RECEIPT DATE: 4-3-23 **ONSITE SEWAGE DISPOSAL SYSTEM** P 574072
 APPROVAL DATE: _____ **PERMIT: CONSTRUCTION** A _____
 PROPERTY ADDRESS: 12363 Pleasant View Drive
 SUBDIVISION: Fulton Manor LOT: 27 TAX ID: 5418178
 CONTRACTOR: Hofffields Equipment EMAIL: Ken@hofffieldsequipment.com
 CONTRACTOR ADDRESS: P.O. Box 519 Annapolis Junction MD 20701 PHONE: 301-490-4289
 PROPERTY OWNER: John Sessler EMAIL: _____
 OWNER ADDRESS: 12363 Pleasant View Drive PHONE: 410-980-9868

LOT 27, FULTON MANOR
ON-SITE SEWAGE DISPOSAL SYSTEM PLAN
12363 PLEASANT VIEW DRIVE
FULTON, MD 21029
TAX#: 418178, SUB: 2204

From: Silvast, Zackary <zsilvast@howardcountymd.gov>
Sent: Thursday, September 8, 2022 6:26 PM
To: Brian Collins <Brian.Collins@kci.com>
Cc: Martin, Sharhonda <smmartin@howardcountymd.gov>
Subject: Regarding 12363 Pleasant View Drive (PC & OSDS plans)

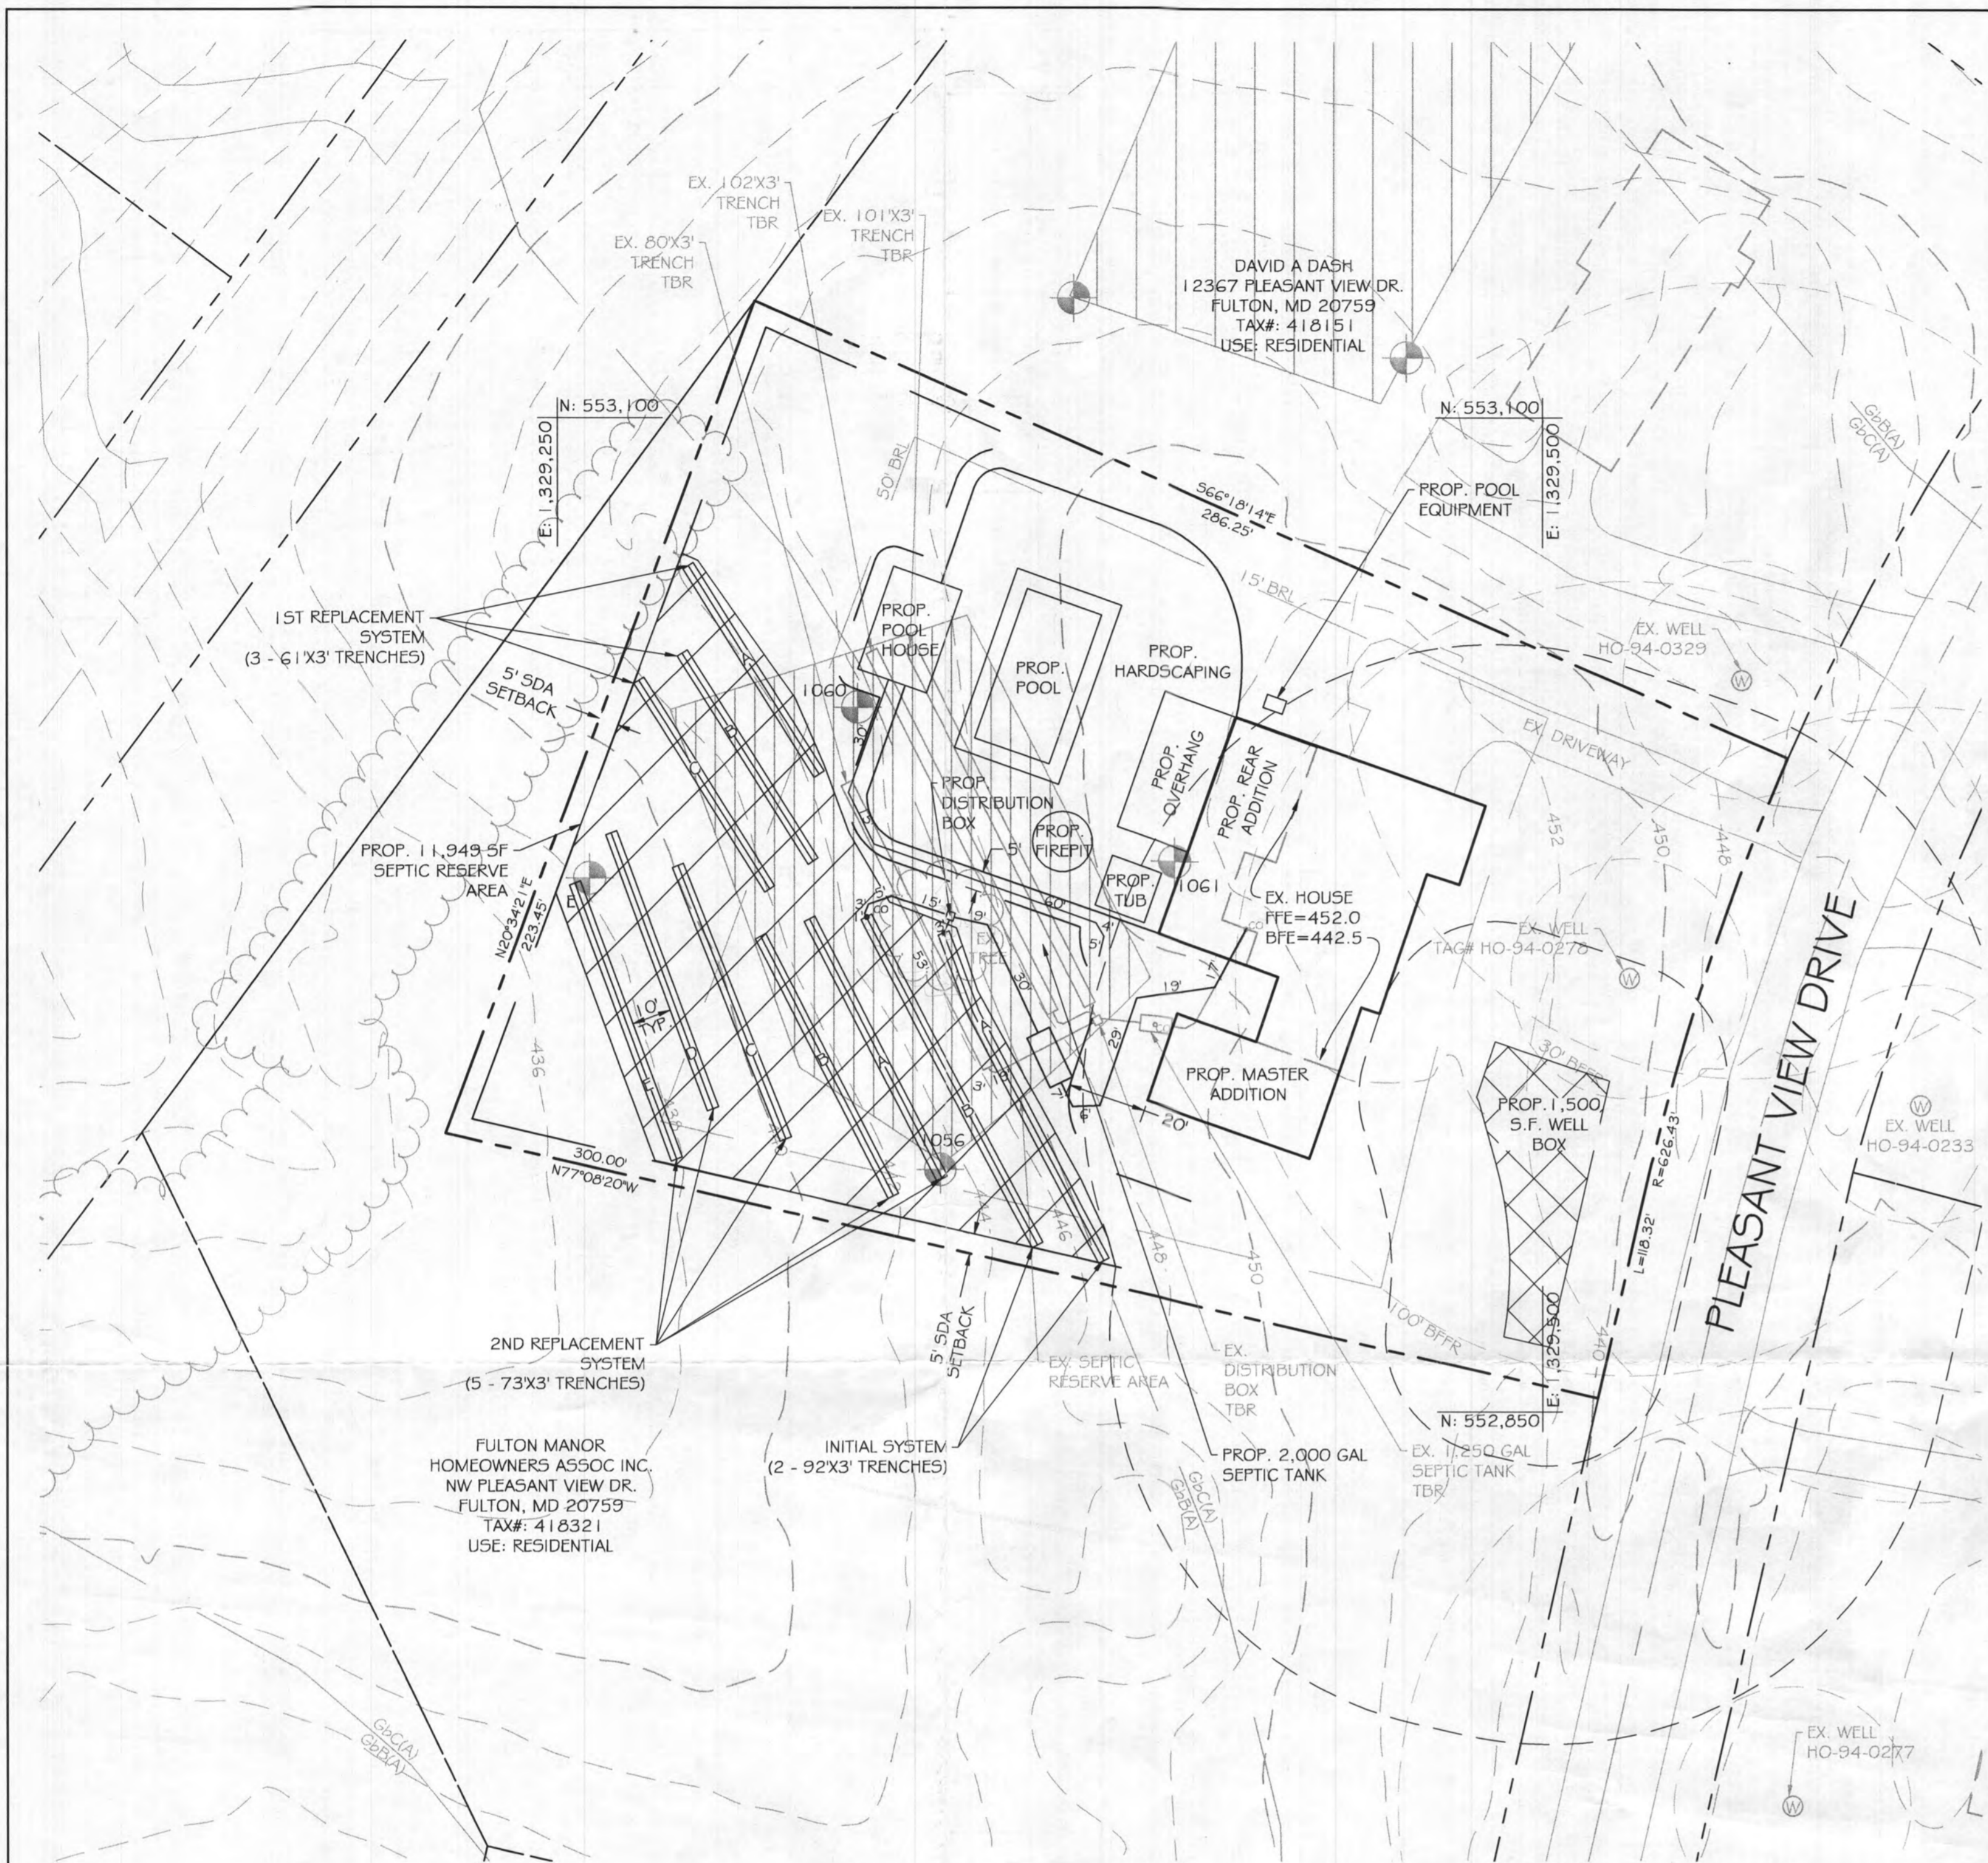
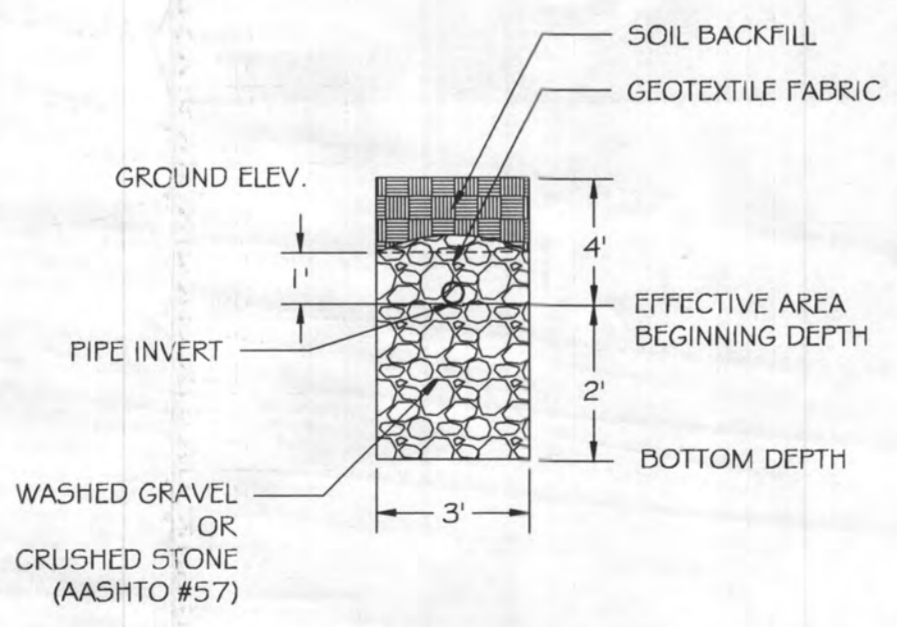
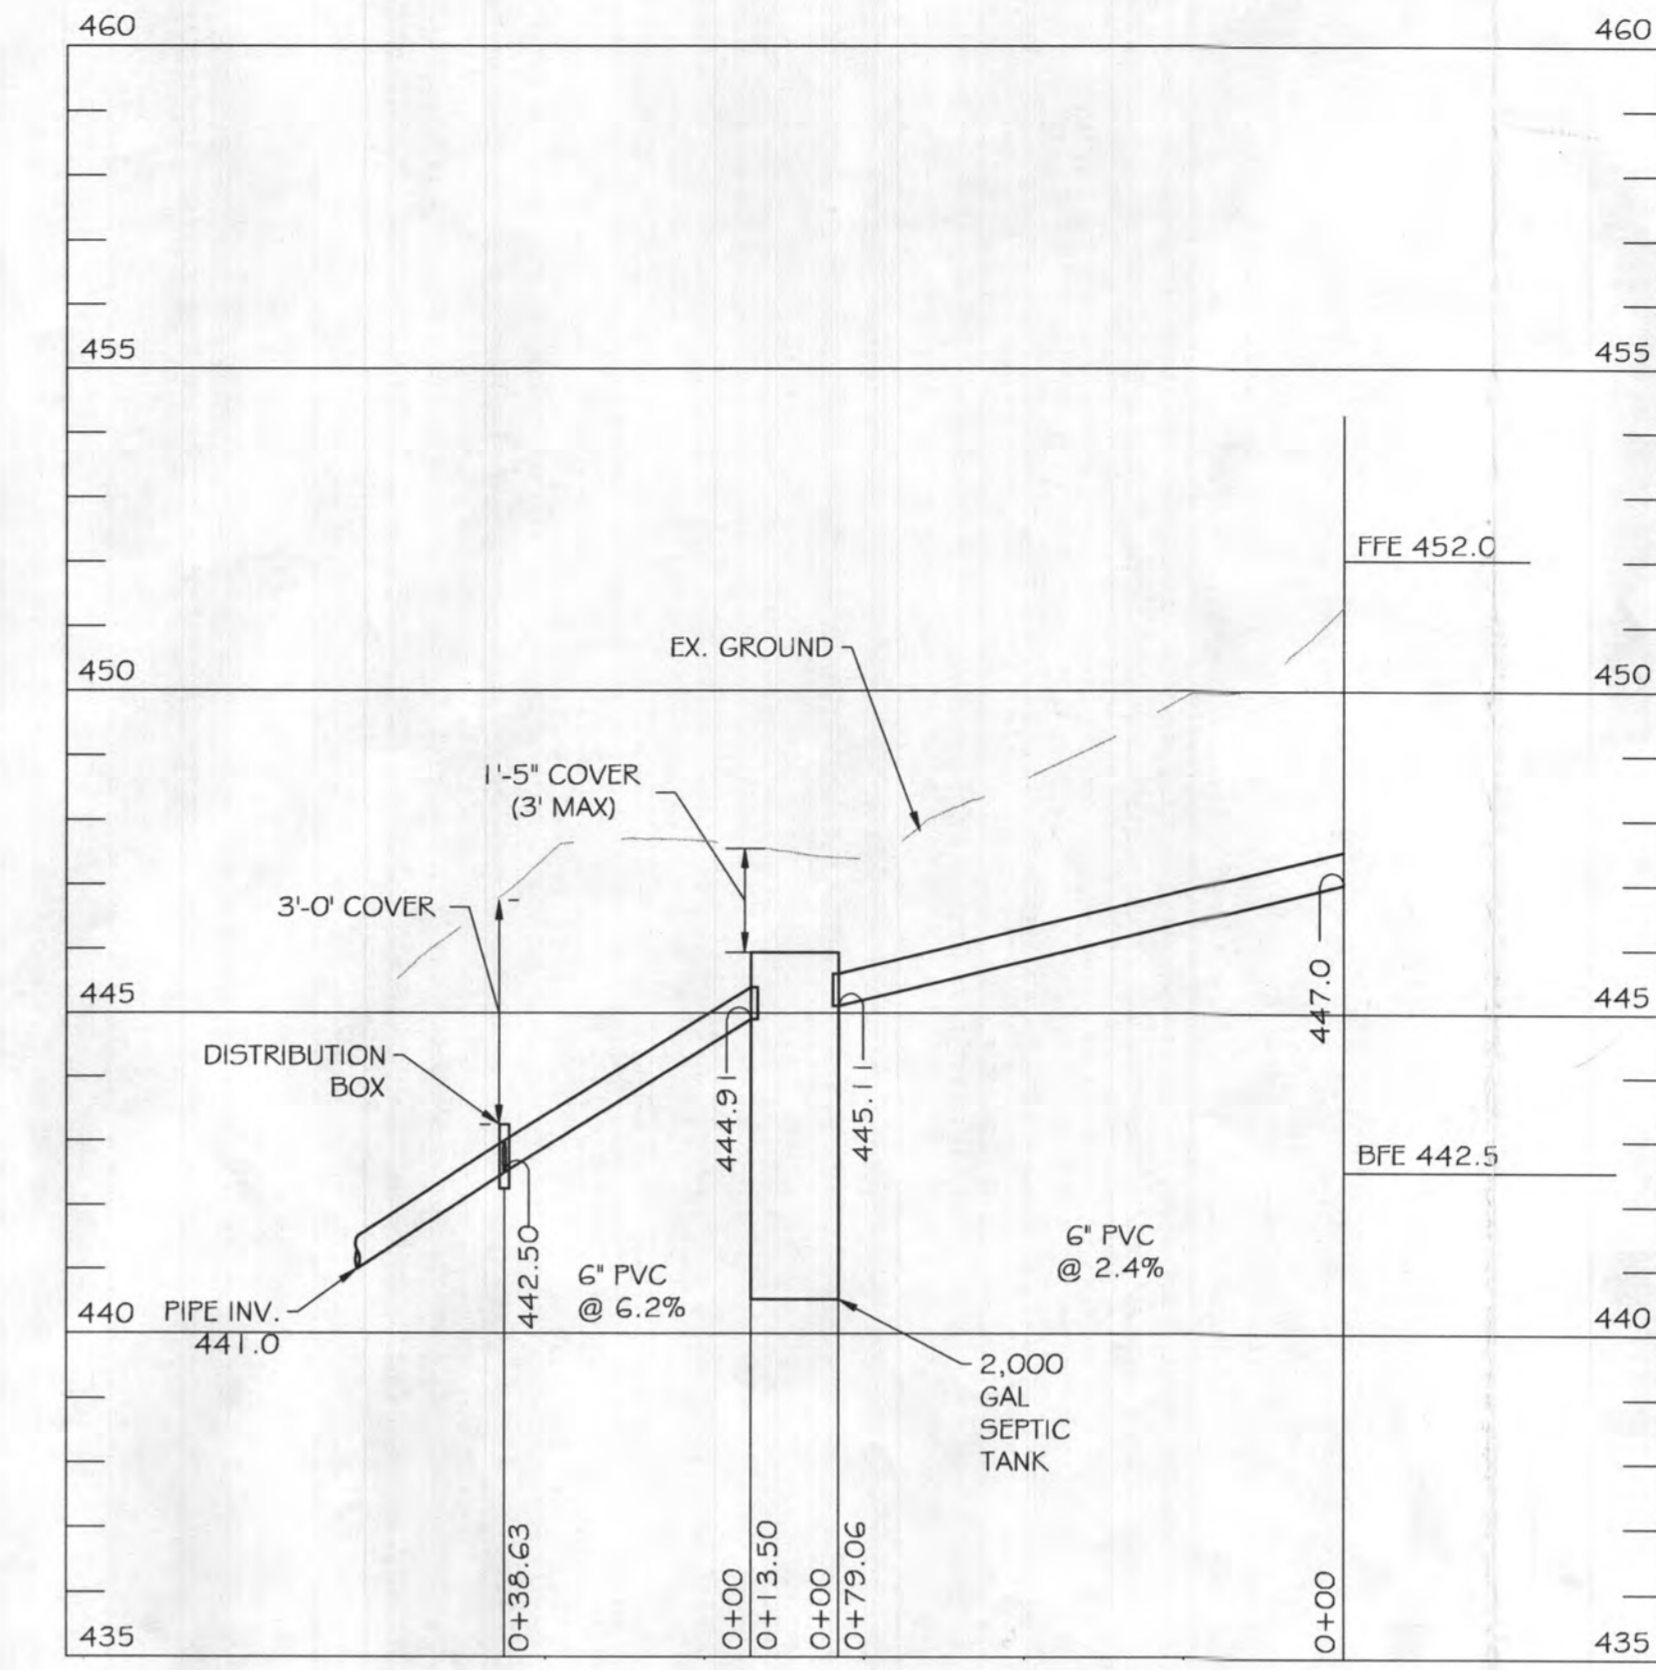
4/19/23 - SDA staked. Tank staked, D-box staked. Laid out 2 trenches @ 92'. Ex tank will be pumped + collapsed. Insulated well to house (RCL SP)

4/19/23 - one tree will have to be removed to install one of the trenches, there is another tree that should be removed right @ the d box location, but home owner said that he'd have it removed after the construction of additions + pool, contractor said that he'd seal the d box w/ mastic to prevent tree root intrusion (RP) 4/20/23 - Spoke to J. Williams who said

INSTALLATION: the tree near the d box's beginning of trenches will need to be removed before the installation starts - relayed this info to contractor. (RP) 4/20/23 - Hatfield's stated that home owner will remove the tree by the d box before installation (RP)

4/21/23 - Trenches installed upon arrival. Installer onsite. Width + Inlet per plan. Pipe for lower trench @ 90' but stone + fabric extends 2' at beginning of trench. Width + Inlet for both trenches per plan. Stone + fabric for both trenches on. Gave OK to backfill trenches. D-box level, saw baffle. Left + came back onsite to see tank. Tank was level. 2' of cover on lid, saw slot. Gave OK to cover; respect for baffles, House + D-box connection. (SP)

4/24/23 - first filler pumped, collapsed + took out existing tank, stone used @ old tank location. SCHED 40 pipe used from tank to existing outlet from house. used existing c/o from house. saw 6" front + 4" back baffles. measured tank to D-box. (SP)

→ tree @ dbox ; beginning of trenches will be removed before OSDS installation
